Proposed revisions to LAX TAC

I suggest the following three revisions for the December chart:

- 1) Removal and replacement of VPLWT
- 2) Correction re radomeS near Pt.Fermin
- 3) Removal and replacement of VPLSP

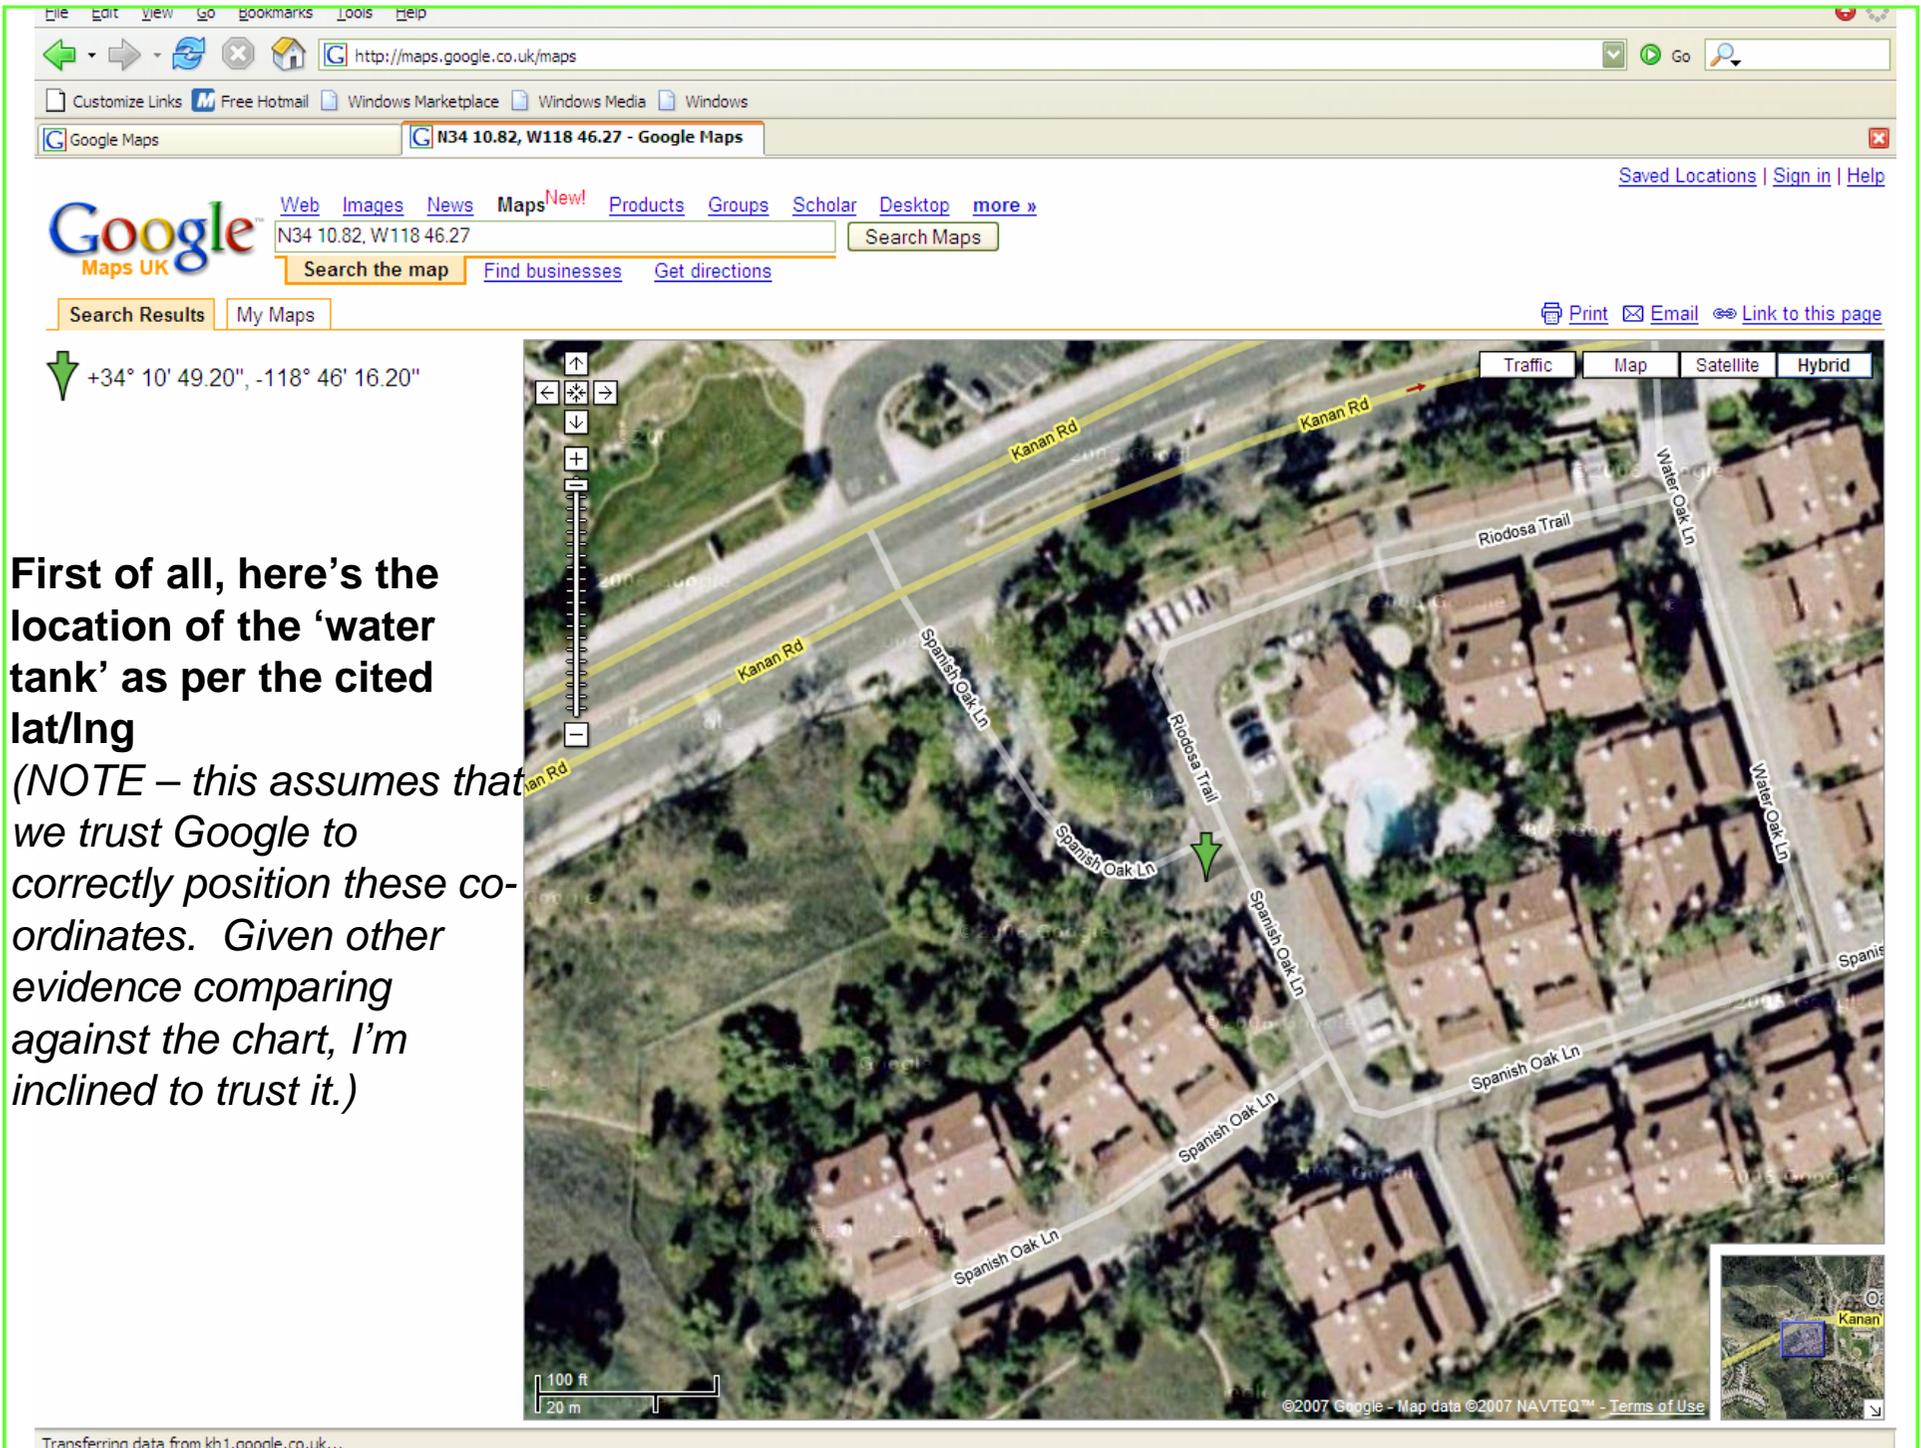
The water tank VPLWT, in the region of Thousand Oaks (16nm E of KCMA), is long past its 'use-by' date as a Visual Reporting Point (VRP - it isn't there any longer!

See the following slides for analysis and evidence (pls verify the lat/ing against the TAC) – I think they leave little room for doubt as to the fact that the actual VRP is no longer present.

First a Google™ map.

- a) the actual disposition of existing water tanks in the area and
- b) the location of VPLWT on the TAC – the TAC seems to place the location (to the best that its scale allows) pretty-much where the Google pointer is directed.

Note – the TAC shows that VPLWT is 2nm Nth of the Fwy101 – the scale on the Google satellite image is entirely consistent, suggesting that this truly is the location at which VPLWT is expected to exist. On a recent flight I used a GPS to confirm the position. There is no water tower there.

I don't think that the solution is to find another water tank – they are two a penny out there. My recommendation would be to remove VPLWT, and find a more obvious alternative if a VRP is required in this vicinity - see proposed VPLGN or VPLWL.

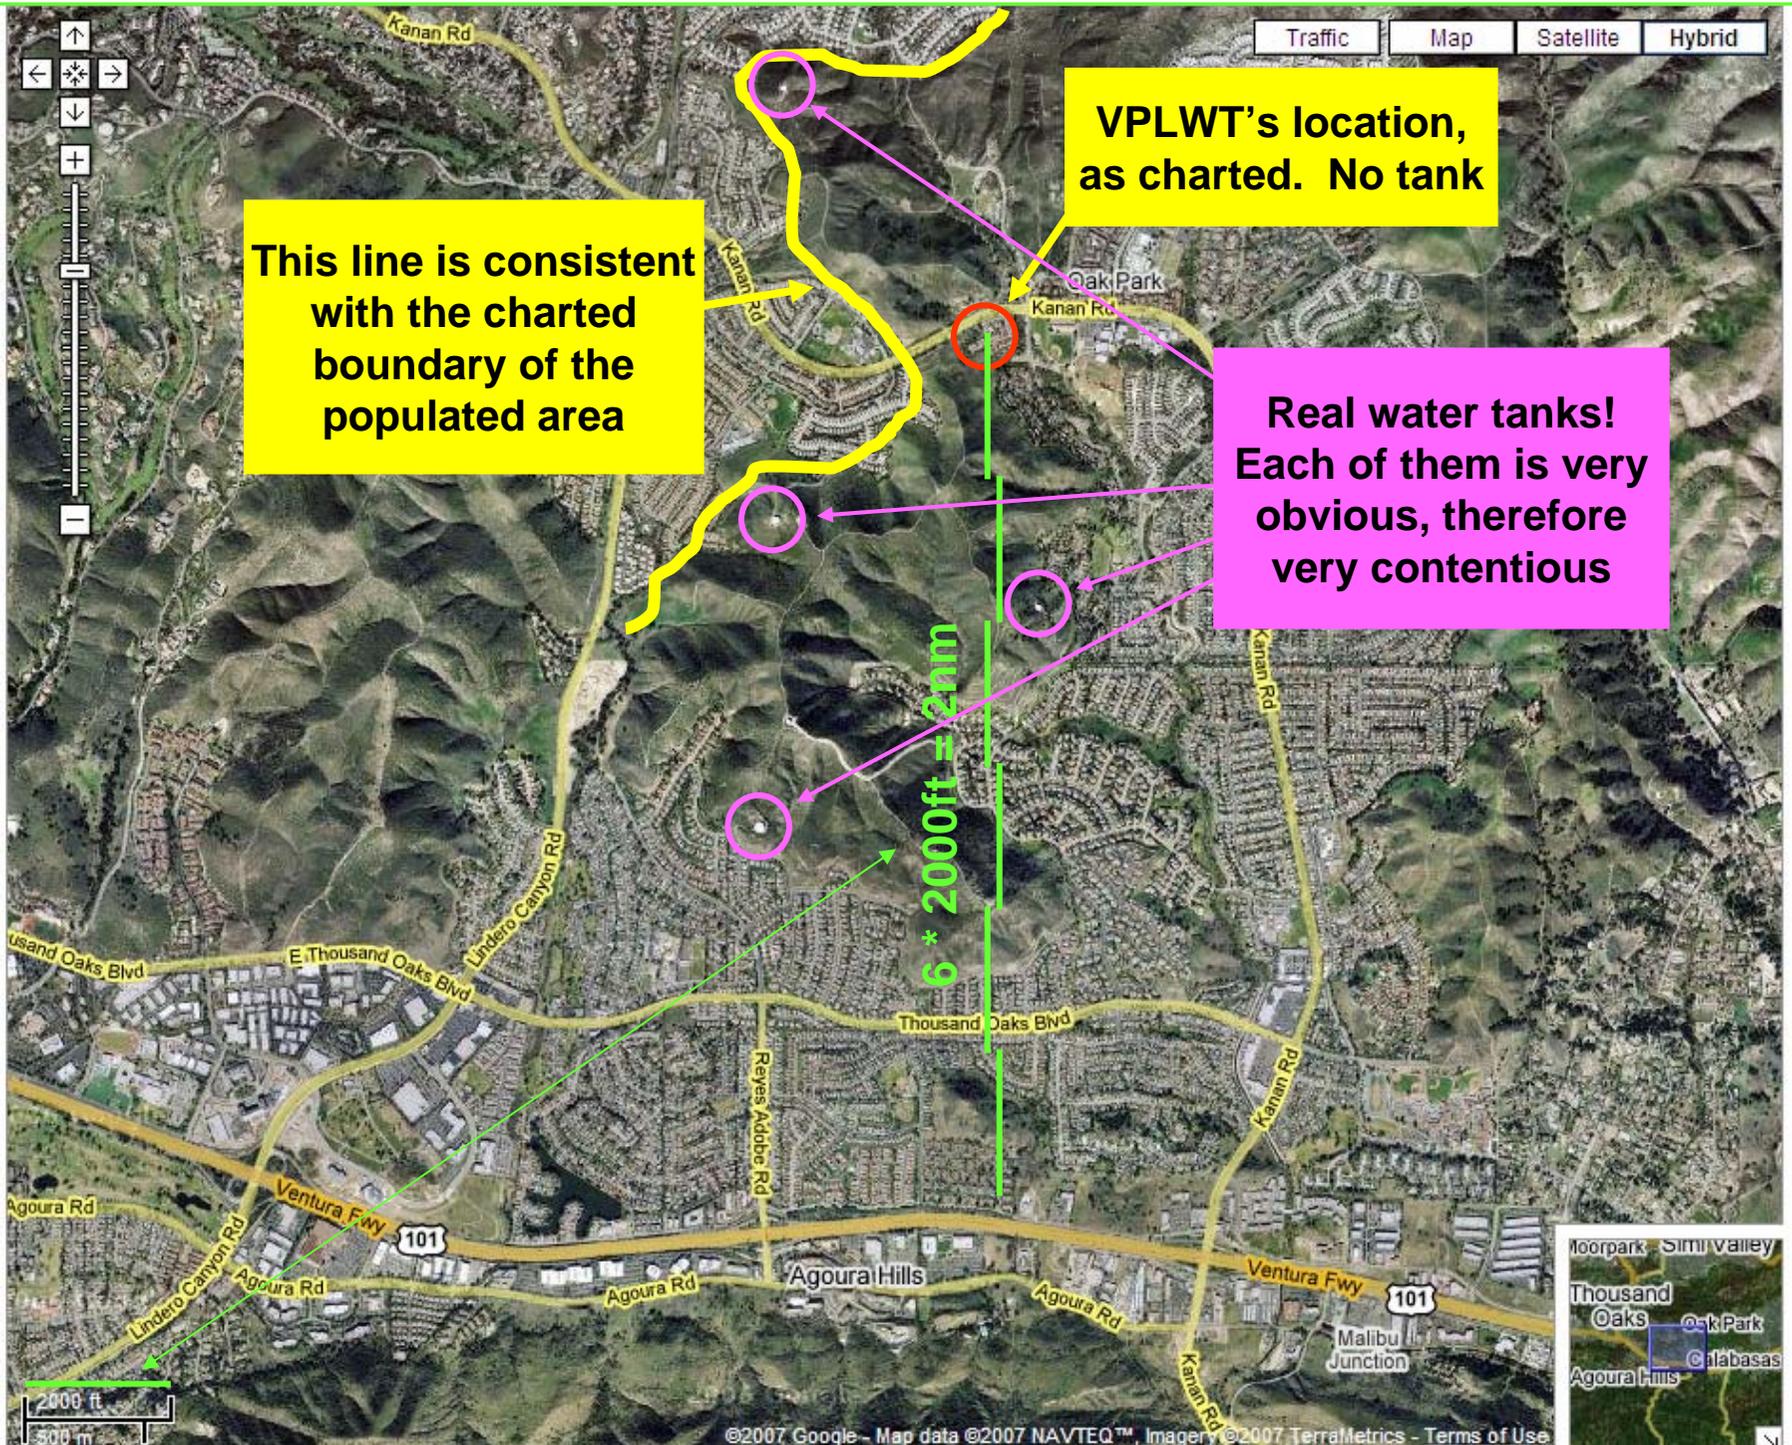
First of all, here's the location of the 'water tank' as per the cited lat/ing

(NOTE – this assumes that we trust Google to correctly position these coordinates. Given other evidence comparing against the chart, I'm inclined to trust it.)

This line is consistent with the charted boundary of the populated area

VPLWT's location, as charted. No tank

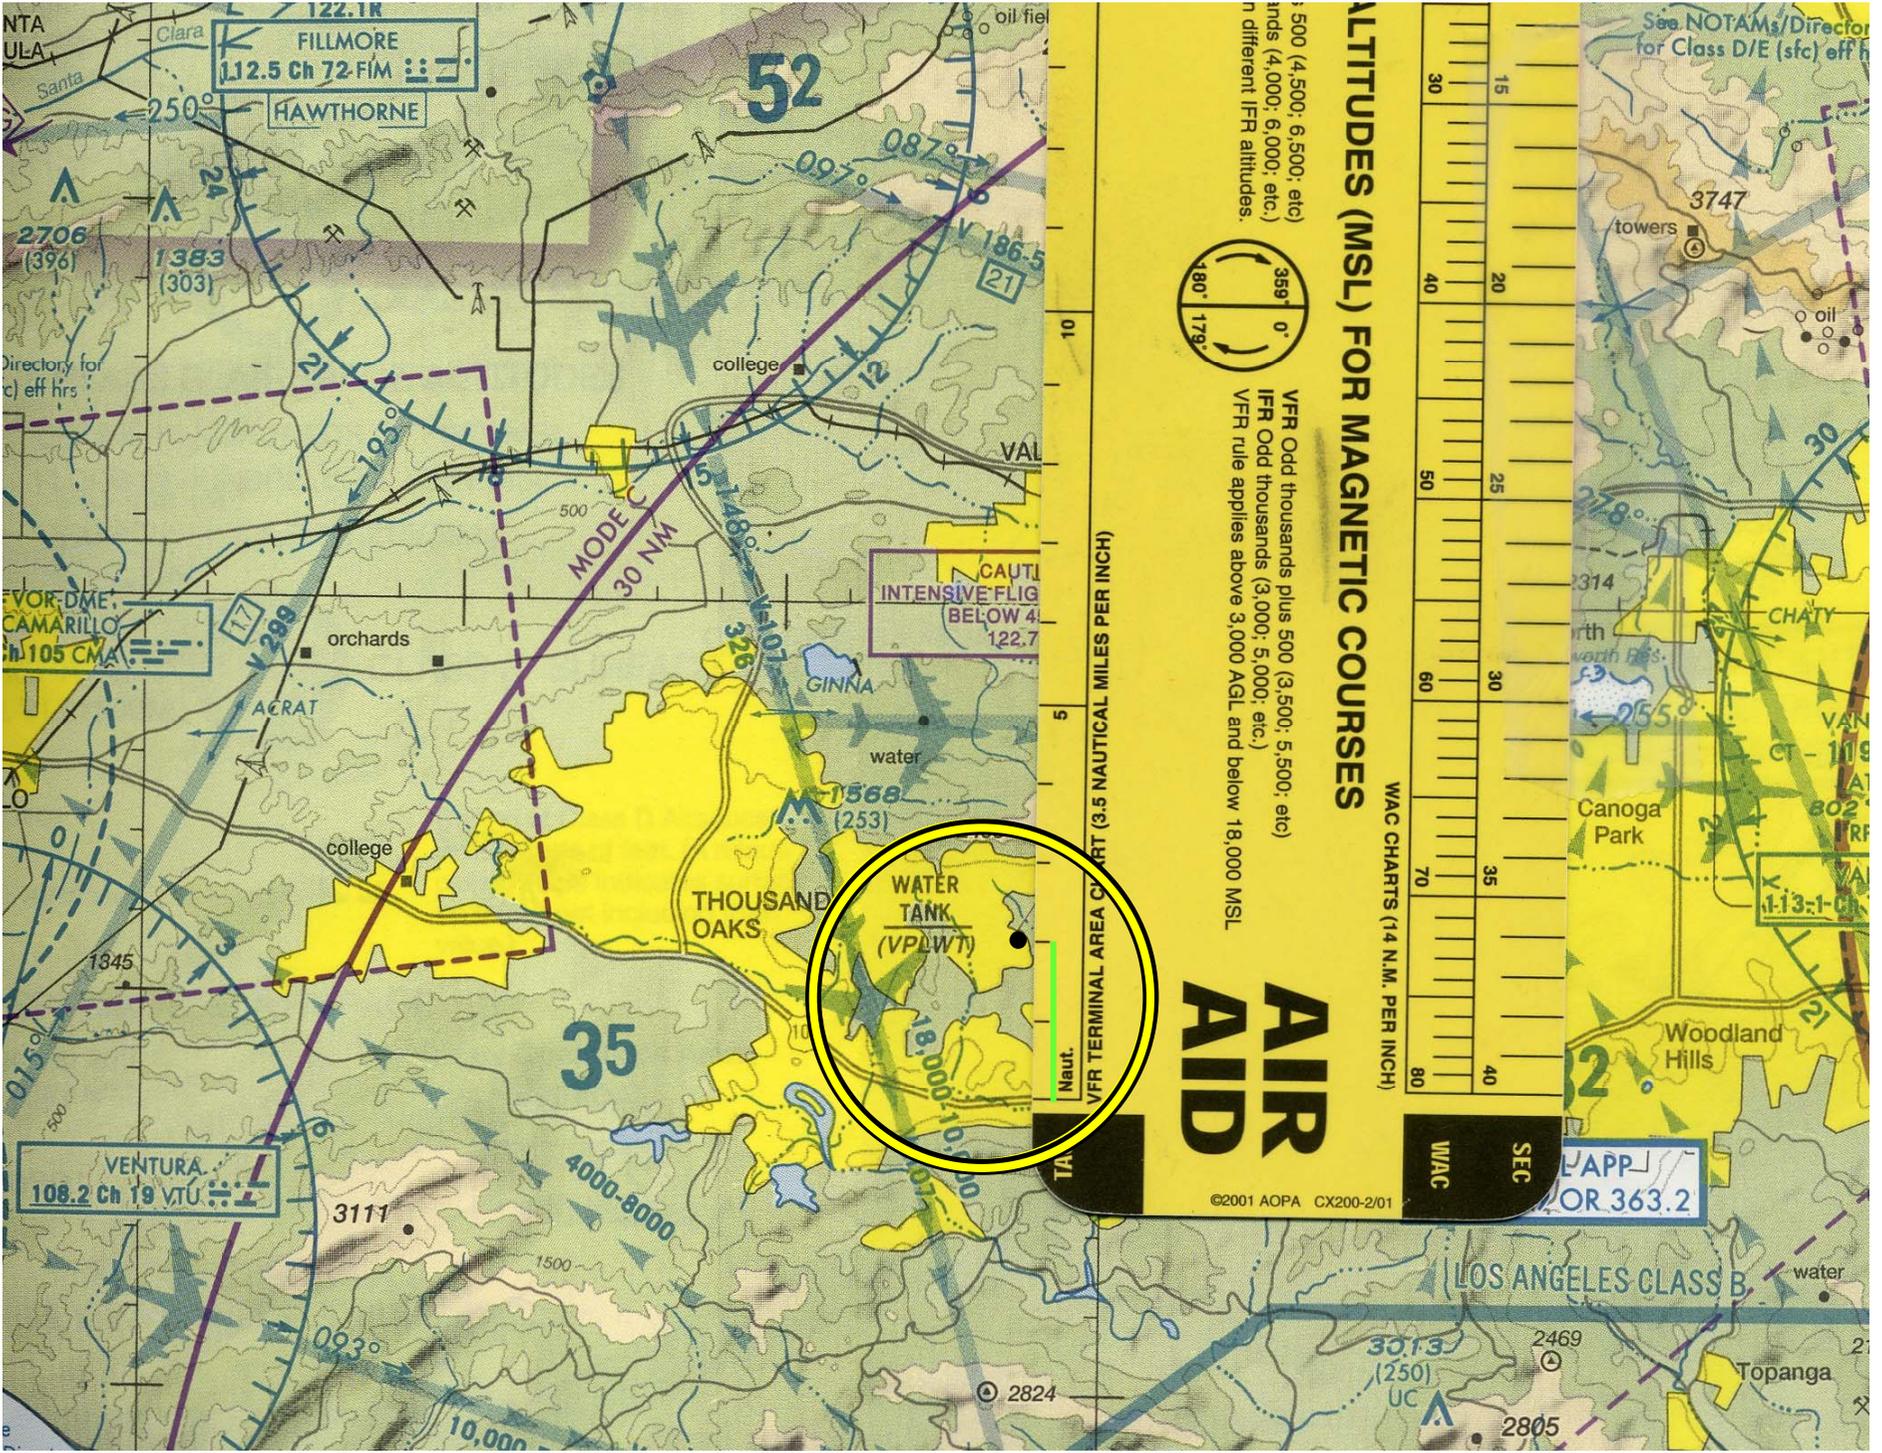
**Real water tanks!
Each of them is very obvious, therefore very contentious**

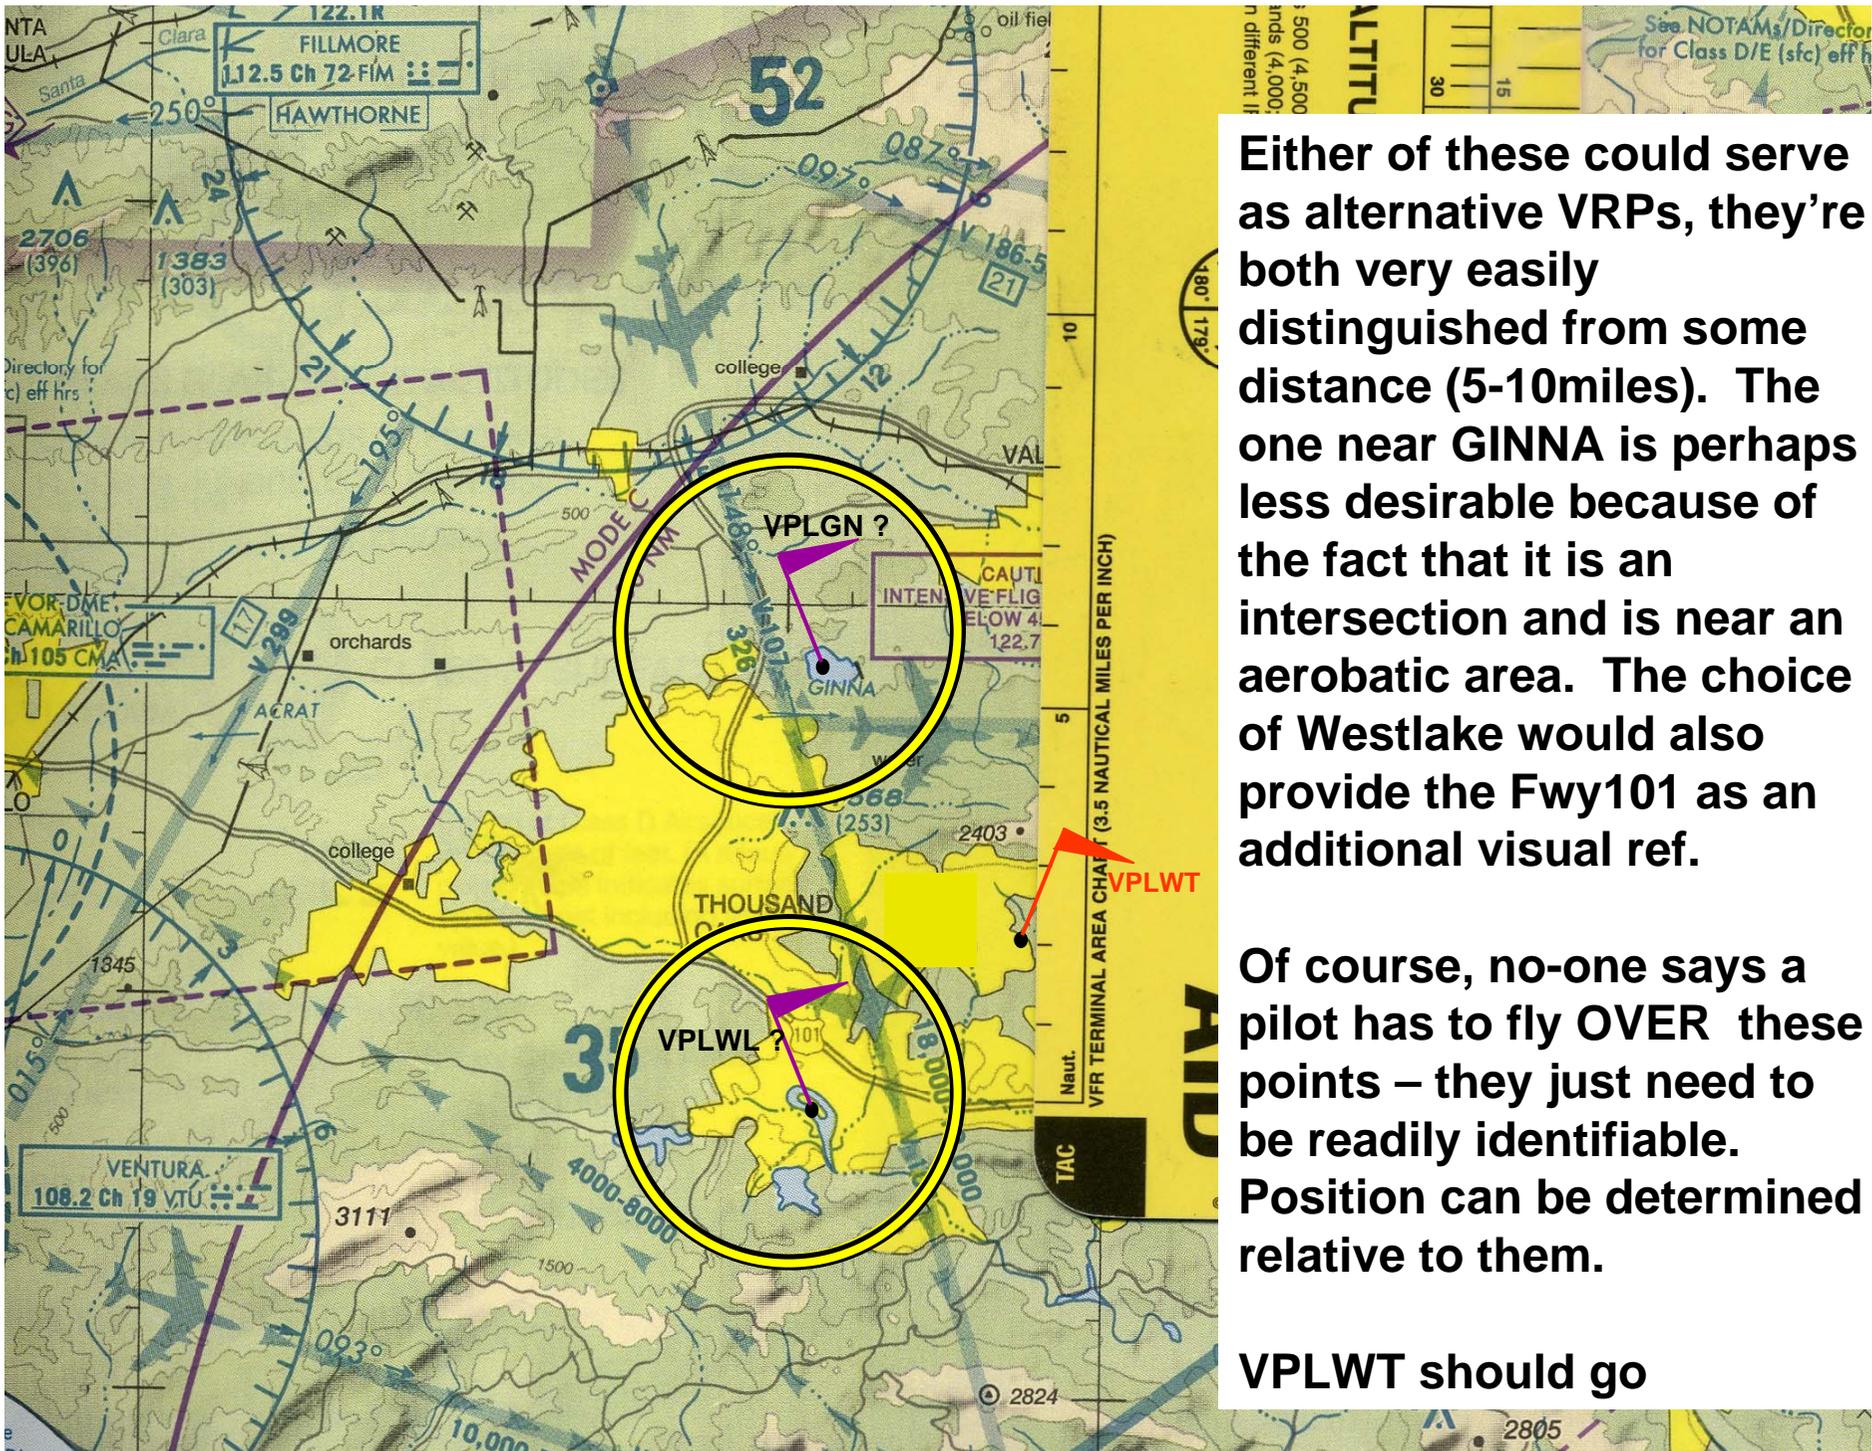
Either of these could serve as alternative VRPs, they're both very easily distinguished from some distance (5-10miles). The one near GINNA is perhaps less desirable because of the fact that it is an intersection and is near an aerobatic area. The choice of Westlake would also provide the Fwy101 as an additional visual ref.

Of course, no-one says a pilot has to fly OVER these points – they just need to be readily identifiable. Position can be determined relative to them.

VPLWT should go
